December 6, 1985

R. E. GINNA CONTAINMENT VESSEL TENDONS
REVIEW OF NRC SAFETY EVALUATION REPORT¹
BY GILBERT/COMMONWEALTH, INC.

FIGURE 32. CREEP EXPONENT VERSUS STRESS

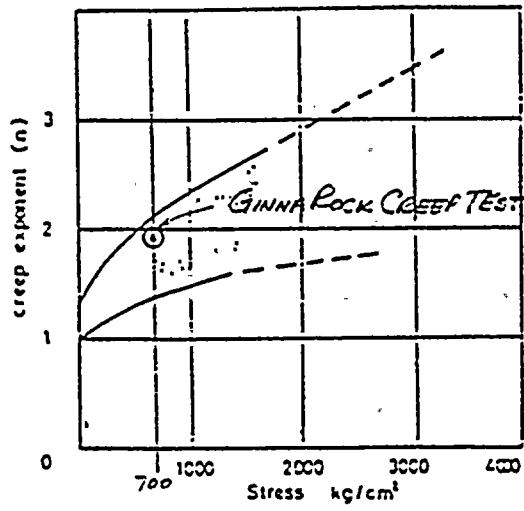
We concur with the comment that the creep extrapolation in GAI Report No. 2347 (FRC Reference 10) is not correct, but there is reason to believe that the tendon loss due to rock creep is much closer to the 8 kip value rather than 122 kips, the range given in GEI's report. An explanation follows.

GEI's report includes Figure 4.5 from Farmer's text Engineering Properties of Rock (1968), which was the basic reference used for the rock creep strain calculations in GAI Report No. 2347 (FRC Reference 10). This figure is reproduced as Figure 32 herein, and it indicates that the creep exponent, n , used to determine the creep strain in the rock increases with increasing compressive stress in the rock. Two curves are shown in the figure which bound test data from different types of rock at various stress levels. From the figure, and as GEI reports, at the 472 psi (33 kg/cm^2) compressive stress used for the creep calculation, the upper bound curve gives a value of 1.4 for n while the lower bound curve yields a value of 1.1 for n . For $n = 1.4$, a rock creep strain is calculated which would result in an 8 kip loss in the tendons. For $n = 1.1$, the tendon force loss is calculated to be 122 kips. Actually, the type of rock at Ginna would appear to exhibit a creep characteristic more closely represented by the upper bound curve that gave 8 kips as the calculated tendon loss. This is seen from the creep data discussed in Section 2.2 of GAI Report No. 2347 (FRC Reference 10). Here, a value of $n = 1.91$ was obtained from a creep test on Ginna site rock under 10,000 psi (703 kg/cm^2) sustained compressive stress. If the value for n of 1.91 is plotted on Figure 4.5 from Farmer at 703 kg/cm^2 , the data point lies close to the upper bound curve (see Figure 32). Consequently, based on the existing calculations, the tendon loss would likely be much closer to 8 kips than 122 kips.

A value for tendon loss due to rock creep in the neighborhood of 8 kips is larger than the 0.08 kip value reported previously. But this difference does not alter the previous conclusion that stress relaxation of the tendon wires is the primary reason for the larger-than-predicted tendon force losses. One reason for maintaining this conclusion is due to the fact that the excessive relaxation (in excess of the original 12% curve) accounted for much more than 8 kips loss of tendon force. Another important reason has to do with the conservatism of the rock column model which yielded the value of

472 psi compressive rock stress. This model was originally chosen because it was convenient and, at the same time, would yield conservatively high values of compressive stress in the rock, and consequently conservative values of rock creep strain, which at the time were determined to be insignificantly small based on the calculations that resulted in the 0.08 kip value. The rock column model, in effect, uses the 472 psi bearing stress under the ring footing on the rock surface and assumes that this level of stress exists uniformly along the entire 34-foot height of the rock anchors. This conservatively ignores the fact that the force corresponding to the 472 psi bearing actually spreads out in the rock below the footing. This effect would reduce the creep strain in the rock, and consequently the tendon loss; below that determined using the rock column assumption. This assumption is also expected to be conservative enough to overcome any additional loss that might be calculated by including the shear deformation of the rock in a less conservative, and more realistic, calculational model for the rock.

Correcting the error pointed out by GEI in the previous rock creep calculation appearing in GAI Report No. 2347 increases the calculated value of tendon loss from that reported previously. But the revised value is based on a very conservative calculational model for the rock; and still, its magnitude is not large enough to alter the previous conclusion that stress relaxation is the primary reason for the larger-than-predicted tendon losses which occurred prior to the June 1980 retensioning. This point is further emphasized by the fact that subsequent to the June 1980 retensioning, the tendon forces measured on three separate occasions at the 1981, 1983, and 1985 surveillances are predictable even ignoring rock creep. This is to be expected since any rock creep that may still be occurring would be doing so at a creep rate that is insignificantly small considering that the rock has been stressed by the rock anchors for 16 years.
